## **CABINET MEMBER FOR ENVIRONMENT – 12 SEPTEMBER 2019**

### **CHALGROVE, MONUMENT ROAD - PROPOSED ZEBRA CROSSINGS**

**Report by Director of Community Operations, Communities**

**Title**  
Proposed Footway and Zebra Crossings General Arrangement

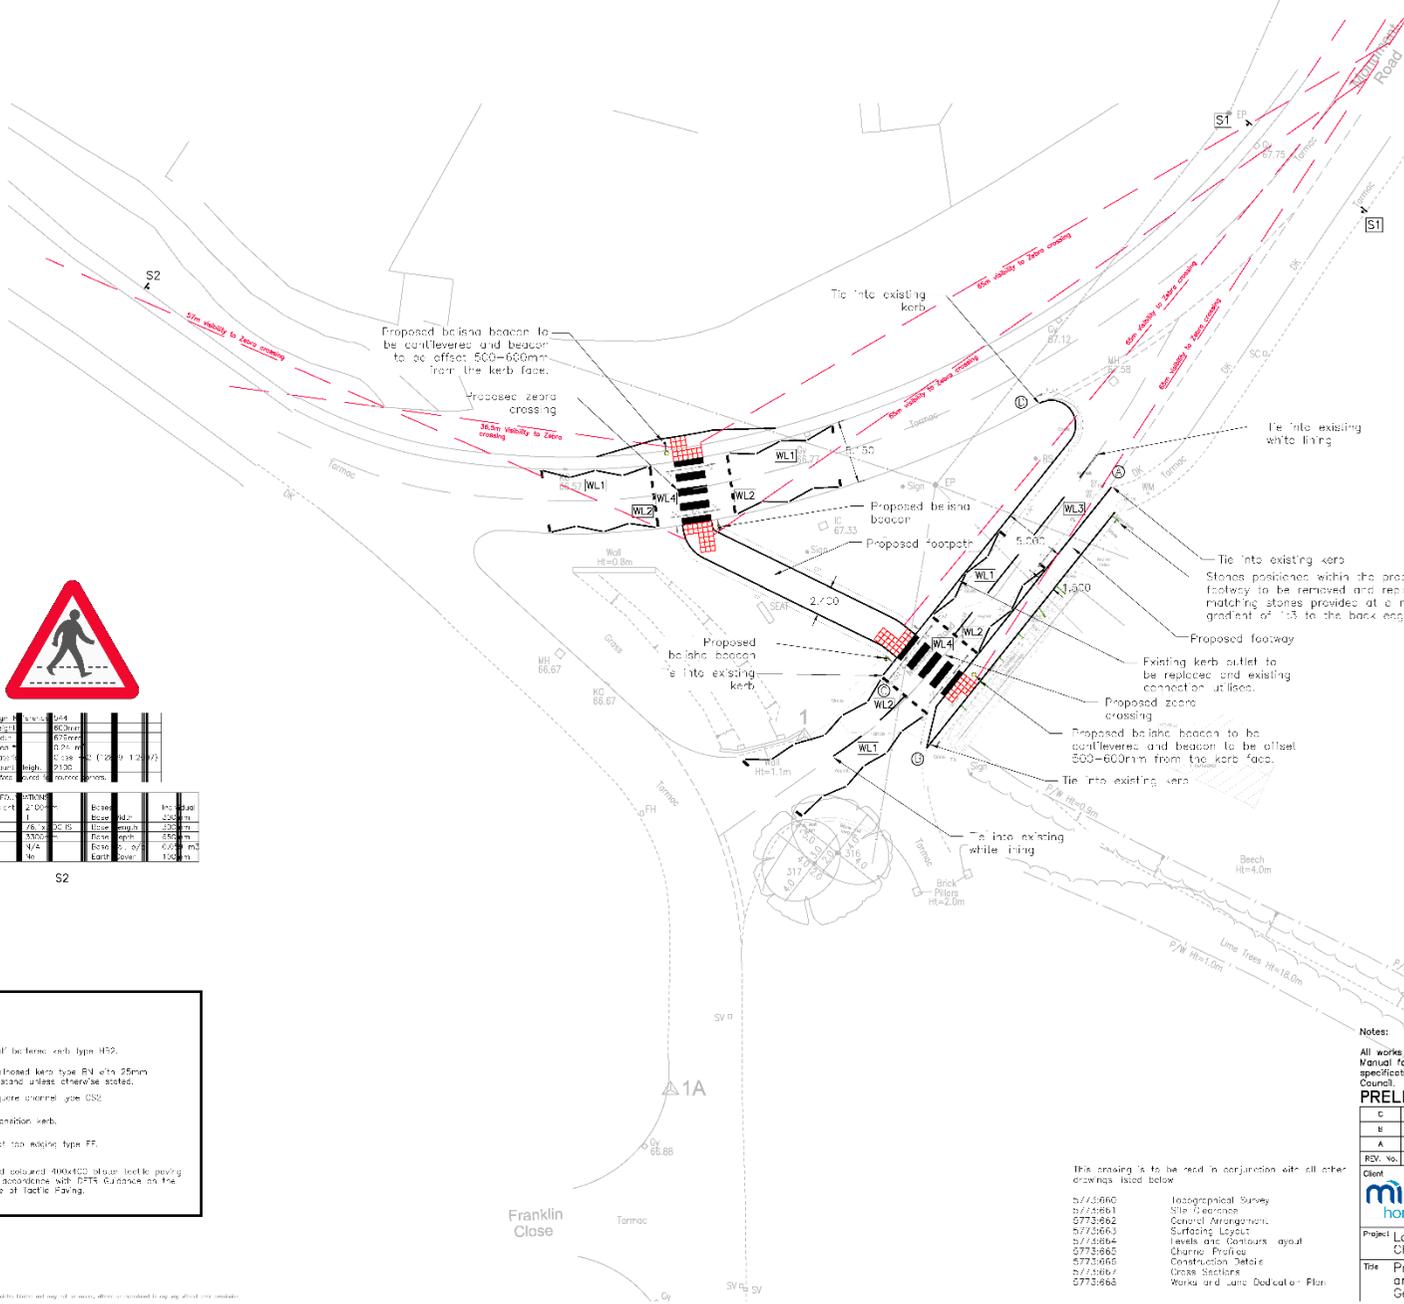
7. Thames Valley Police have not objected to the proposals.
8. Chalgrove Parish Council objected on the grounds of safety due to the proximity of the crossings to junctions and a bend and on the grounds of visual amenity also noting that the footways linking to the crossings are narrow and not continuous. They suggested consideration of an alternative location further along Monument Road or not proceeding at all with any formal crossings. The parish council also noted that both they and South Oxfordshire District Council were not supportive of the residential development but that planning consent had been granted on appeal.

9. Objections were also received from twelve members of the public. Safety was cited as the key concern by the majority of respondents but there were also concerns over the loss of visual amenity; need for the crossing; substandard footway provision adjacent to the crossing noting that other locations in the village – particularly near the primary school – would be a higher priority location for a crossing. A concern was also raised by one member of the public over flooding risks at the site and the need for footways to be sited further away from the brook

| RESPONDENT   | SUMMARISED COMMENTS  |
|--|--|
| (2) Parish Council, (Chalgrove)                        | <p><b>Object</b> – Chalgrove Parish Council and the Chalgrove Neighbourhood Plan both objected to the planning application for the development to the east of Chalgrove – P18/S1853/RM. It is outside the village with only one direct pedestrian access into the village via a small footpath leading onto a dangerous bend in the road, followed by pavements on the High Street which are wholly inadequate for pushchairs and families.</p> <p>It was felt that any form of crossings in this location would be incredibly dangerous; one on the main road on a bend as people exit the village, and the other on a slip road near a narrow bridge on a bend, and close to another junction. Both proposed crossings give drivers very little time to stop. They would also be the first crossings in the village, spoiling an attractive scene as one enters.</p> <p>South Oxfordshire District Council agreed with Chalgrove Parish Council and refused planning permission, however the Inspector appeared to ignore our concerns over safety and granted planning permission on appeal. We are where we are, and therefore leave it to you to make the final decision:</p> <ul style="list-style-type: none"> <li>(a) the installation of unsafe crossings leading to a pavement which ceases within 100 yards</li> <li>(b) reliance on the public crossing the road safely without the use of crossings, as they do now</li> <li>(c) installation of safe crossings further up Monument Road, leading onto Fairfax Road</li> </ul> <p>For your information, following discussions with the developer, we have requested a barrier be erected at the end of the footpath to prevent cyclists and children from running into the slip road. Your consultation makes no mention of this, but we feel this to be essential.</p> |

| <p>(4) Local Resident,<br/>(Chalgrove)</p> | <p><b>Object</b> – The position of the crossing on the bend where the High Street meets with Monument Road is, in my view, completely unsafe and dangerous. It is on a blind bend which traffic already has difficulty navigating when there is passing traffic. I do not consider that there are sufficient sight lines for this proposed crossing and would be an accident waiting to happen. Traffic often approaches that bend way too fast and I do not consider there to be sufficient stopping distances to avoid traffic hitting pedestrians using the crossing.</p> <p>I would also comment that, as a village, we have campaigned on numerous occasions for a crossing outside our school but to no avail. Yet here we are with a new development (granted on appeal) and suddenly zebra crossing are okay?</p> <p>The crossings proposed are not in keeping with our village and alternative solutions should be sought. There would clearly need to be a pathway between the 2 crossings which would ruin the grass area in that area. This is a focal point of the village with the brick bridge and stream and should be preserved.</p> <p>I would urge that the developers are requested to consider alternative solutions to pedestrians accessing the village from their site.</p>                                    |

Firstly, the proposed crossing on the northmost spur of Monument Road. On the north side of Monument Road, the current pavement is less than 1m in width, and there is no pavement on the opposite side of the road. The footways do not meet the standard design criteria of 2.0m in width, with a clear space of at least 1.5m. In addition, as this is an area where people will congregate to use the crossing, the footway width should be 3m wide. It is absolutely clear that the provision of a crossing at this point will result in congestion on the pavement and will not allow for passage of wheelchairs or pushchairs/prams. The plan shown includes tactile paving which extends beyond the boundary of the existing footway. The total off-footway congregation space is 1.2m x 1.2m, which is insufficient as an area for congregating.

On the south side of Monument Road, the footway is shown as 2.4m wide. This will not be matched on the north side. The inclusion of belisha beacons in this area will compromise the quiet enjoyment of the area for neighbouring houses on Monument Road and Farm Close; they will be intrusive and out of character for the village. There are no other Zebra crossings or beacons anywhere else in the village, not even outside the School. The visibility splays are exaggerated. The camber of the bank to the north of the footway reduces the visibility when travelling south on Monument Road.

Secondly, the proposed crossing on the southern spur of Monument Road. The proposed footway to link the existing footpath to the proposed Zebra crossing crosses private land, which will require compulsory purchase; this is unnecessary and undesirable. The resulting footway will not meet design standards, as the width is only 1.5m, not the recommended 2m. The area for people to congregate is likewise not large enough to meet design standards. The access to the Zebra crossing from the footpath will cross the driveway of The Grange, which adds an additional danger to the access.

The most important issue with this crossing is the visibility for traffic travelling north on Berrick Road and heading north up Monument Road. The visibility to the Zebra Crossing is absolutely minimal, being an absolute maximum of 15m, which is significantly below legal limits. The approach is blocked by the brick wall which forms the bridge over the Chalgrove Brook, and several trees. This is a busy route for people using Berrick Road and Monument Road as a route to reach Monument Business Park, and absolutely no consideration has been given to the safety aspects of traffic using this route and coming to the crossing completely unsighted. This is a major public safety issue that was highlighted when the original plan for development to the east of Chalgrove was proposed and was ignored by the Inspector.

| <p>(6) Local Resident,<br/>(Chalgrove)</p> | <p><b>Object</b> - The proposed crossing on the slip road from Monument Rd to Berrick Road is to be situated in dangerous proximity to a blind bend for vehicles coming from Berrick: a large proportion of these vehicles fail to indicate, go too fast and cut the corner over the bridge. Children walking to the village school will be put at high and unacceptable risk to their safety, having to cross a road on 3 occasions on the short journey to their school.</p> <p>Instead of the unsatisfactory proposal for Zebra Crossings, a footbridge of suitable height, incorporating industrial scale lifts for prams, mobility scooters etc from the bridleway from the new housing development, over the stream and Berrick Rd to the green adjacent to Franklin Close should be installed and thus minimize the risk associated with the current poorly thought out proposal.</p> |

| <p>(12) Local Resident,<br/>(Chalgrove)</p> | <p><b>Object</b> - The bend on which one part of the zebra crossing is recommended is already a dangerously narrow part of the road where Monument Road meets the High Street. Two large vehicles cannot pass at this point and it is regularly used by double decker buses. The approach to the crossing from either the Monument Road or the High Street direction is blind to oncoming traffic. The only way that a crossing could be put in effectively would be further up Monument Road towards the bypass but of course children would be inclined to cross in the most dangerous part which is opposite the proposed footpath. It is essential that there are clear signs in advance of the proposed crossing in both directions to slow down traffic and ensure users who are used to the road recognize that a crossing now exists. The only really safe option would be a bridge over the road.</p> <p>To bring about a general improvement the road would need to be widened on the bend by cutting back part of the grass verge. Due to the narrowness of the road on this bend one could envisage a head on collision at the very point where the proposed zebra crossing is to be located.</p> |
| <p>(13) Local Resident,<br/>(Chalgrove)</p> | <p><b>Object</b> - Reasons against:</p> <p>The zebra crossings are right on the bend making it unsafe for both pedestrians and drivers.<br/>The zebra crossing send children on the wrong side of the road to the school, they will only need to cross later where there is no Zebra crossing where more children cross from the rest of the village<br/>A zebra crossing is needed by the school first, if it is deemed not necessary there where at least 75% more children cross then why would one be needed for a small housing estate on a less busy junction<br/>It was never deemed necessary for children and people who live in that part of the village before so why is it now?</p>   |

10. In respect of the safety concerns, an independent road safety audit has been completed and all the recommendations raised were accepted and incorporated in the design. The wider concerns on the visual amenity and existing adjacent footway provision are noted and while it is accepted that a balance needs to be struck between providing pedestrian crossings and the wider considerations raised by respondents it needs to be noted that there would be no other opportunity in the foreseeable future to fund the crossings and that the new residential development can be expected to increase the number of pedestrian crossing movements here.

11. It is not considered that crossings at other locations could reasonably be funded by the development as suggested by some of the respondents nor is the flood risk identified by one respondent affected by or materially relevant to the proposal.
